Service Bulletin No: 52-005

Modification No: EC-14-0175

**CANOPY - GENERAL  
INSPECTION FOR CORRECT INSTALLATION OF THE HINGE ATTACHMENT RIVNUTS****1. Planning Information****A. Effectivity**

Rivnuts - Inspection  
Figure 1

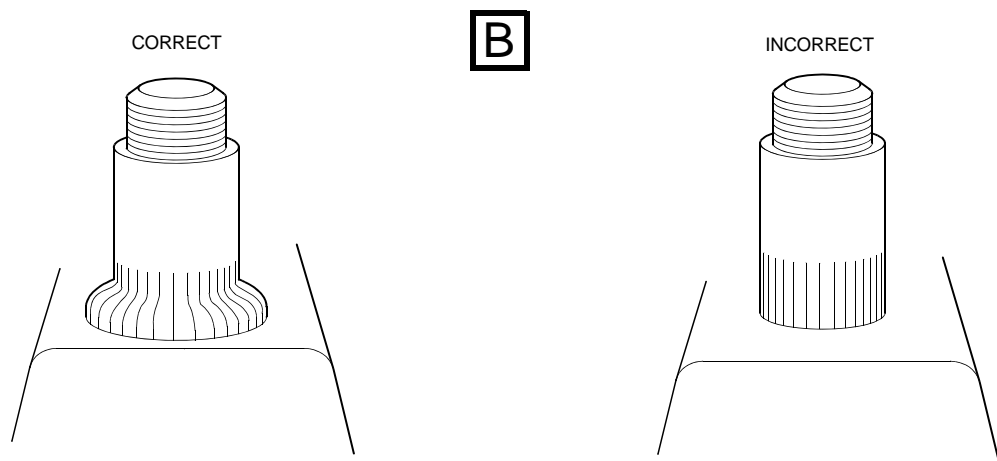
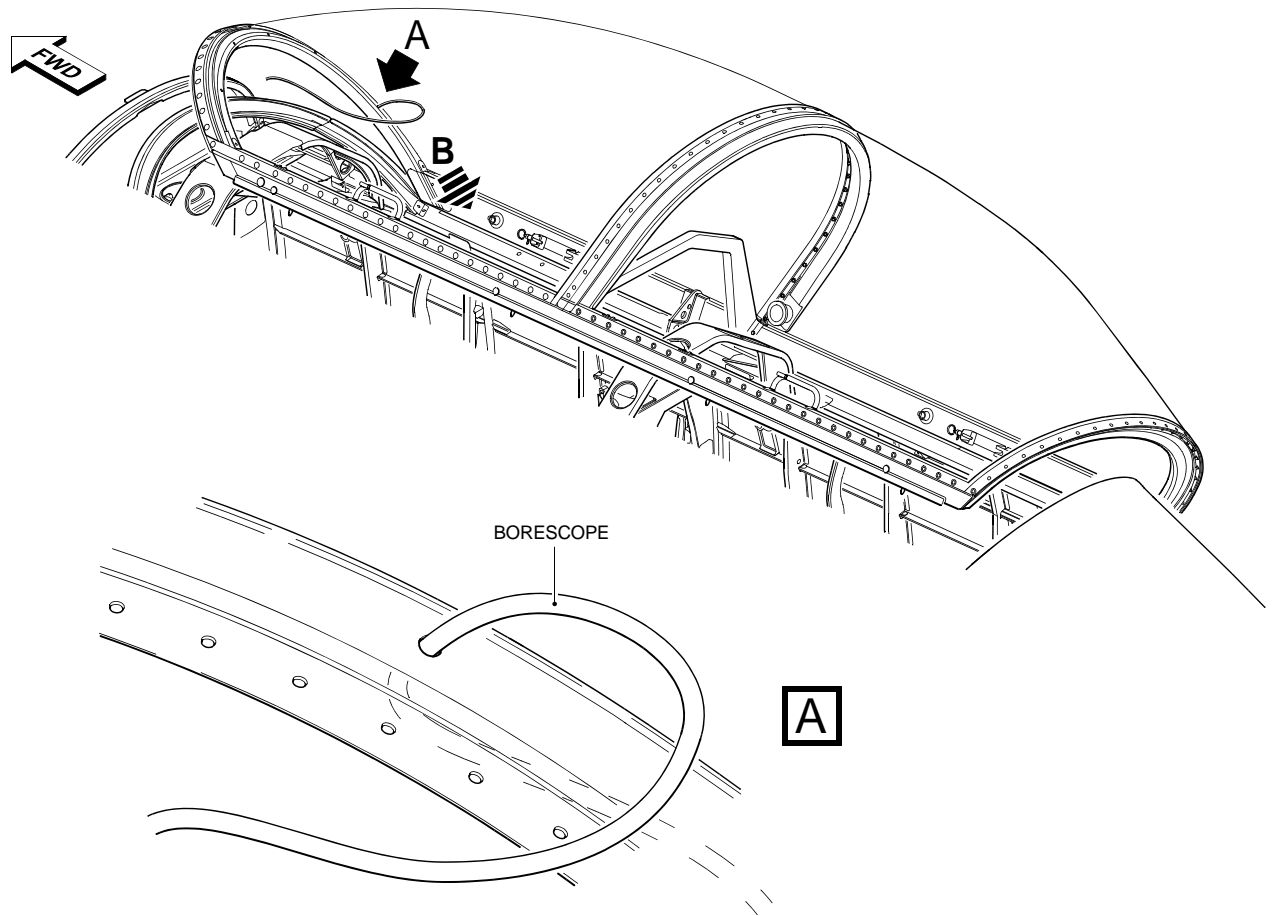
**B. Inspection of the Rivnuts (Ref. Fig. 1)**

- (1) Put the flexible borescope through the tooling hole in the right side of the front frame of the canopy.
- (2) Push the flexible borescope into the right side frame until you can see the rivnuts.
- (3) Examine the first four hinge attachment-screw rivnuts (minimum).
- (4) If the rivnuts have a bulge they are correctly installed. Remove the borescope and do the re-identification procedure (Ref. Para. F.).
- (5) If the rivnuts are cylindrical with no bulge they are not correctly installed. Continue with the rivnut installation procedures.

**FIG. 2a**  
**INSTALL TOOL**

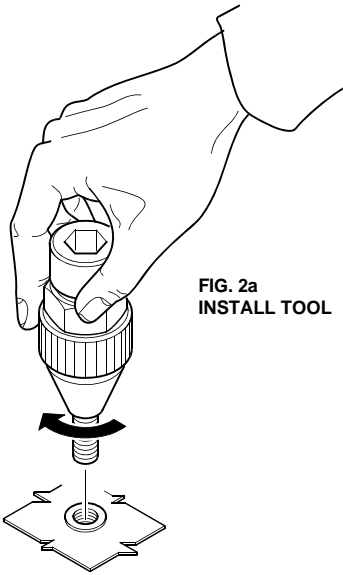
- (1) If the rivnuts are serviceable, use the Rivnut Handtool (P/N 513.53.09.029) and pull the rivnuts as follows (Ref. Fig. 2):
  - (a) Install the hand tool in the rivnut (Ref. Fig. 2a):
    - 1 Engage the threads of the pull-up stud (on the hand tool) with the threads of the installed rivnut.
    - 2 Turn the complete tool clockwise to fully install the pull up stud in the rivnut.
    - 3 Turn the anvil until it is tight against the head of the rivnut.

**FIG. 2b**  
**PULL RIVNUT**

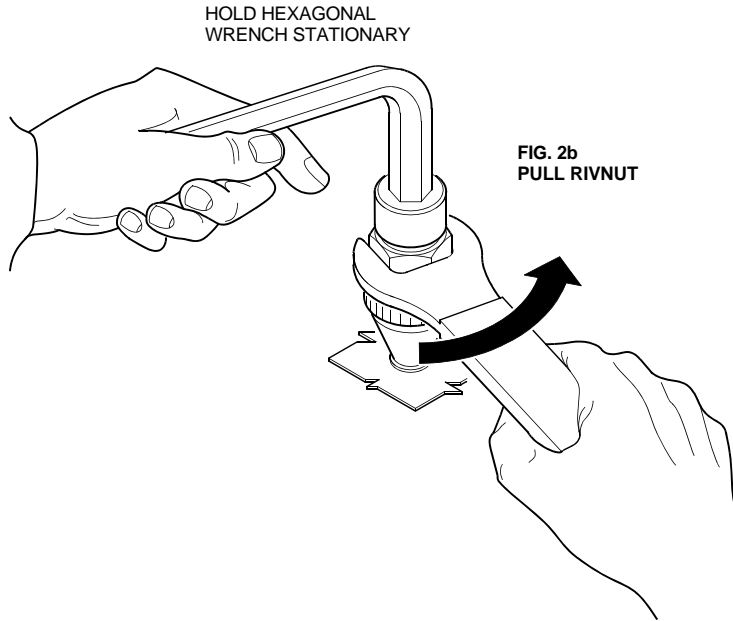
- (b) Pull the rivnut (Ref. Fig. 2b):

**CAUTION:** MAKE SURE YOU HOLD THE HAND TOOL PERPENDICULAR TO THE SURFACE OF THE CANOPY FRAME. YOU MUST NOT INSTALL THE RIVNUT AT AN ANGLE.

- 1 Insert the hexagonal wrench in the jackscrew of the hand tool.

**CAUTION:** DO NOT PERMIT THE HEXAGONAL WRENCH TO TURN WHEN YOU PULL THE RIVNUT. DAMAGE TO THE HANDTOOL CAN RESULT.

- 2 Hold the hexagonal wrench stationary.

**CAUTION:** DO NOT TURN THE LARGE HEXAGONAL NUT MORE THAN 3/4 OF A TURN. DAMAGE TO THE HANDTOOL CAN RESULT.

- 3 Use a wrench to turn the large hexagonal nut counter-clockwise for 3/4 of a turn.

**NOTE:** 3/4 of a turn is the maximum required to completely deform the sleeve of a rivnut that is not correctly installed.

**FIG. 2c**  
**LOOSEN TOOL**

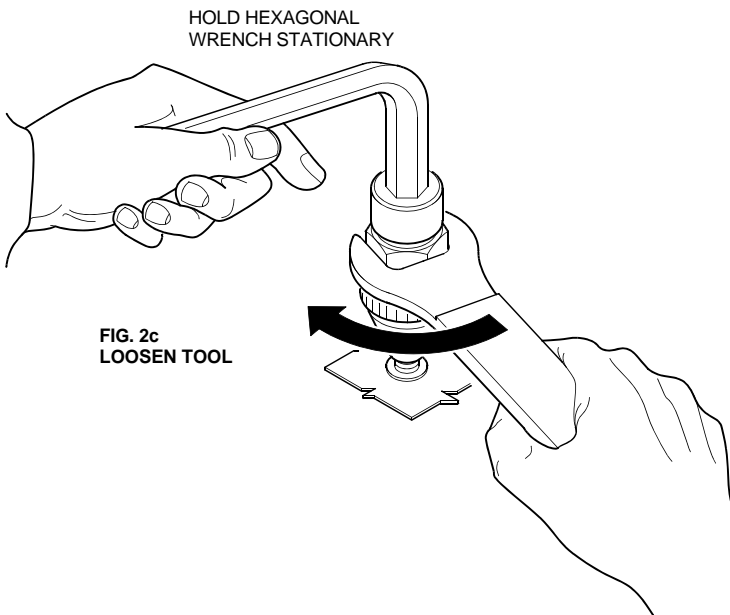
- (c) Loosen the hand tool (Ref. Fig. 2c):

- 1 Hold the hexagonal wrench stationary.

- 2 Break the large hexagonal nut loose with a clockwise turn.

- 3 Remove the two wrenches from the hand tool.

**FIG. 2d**  
**REMOVE TOOL**

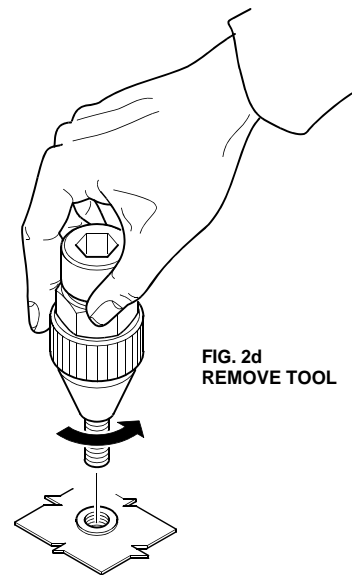
- (d) Remove the hand tool (Ref. Fig. 2d):

- 1 Turn the complete tool counter-clockwise to remove the pull-up stud from the rivnut.

- 2 Remove the hand tool.
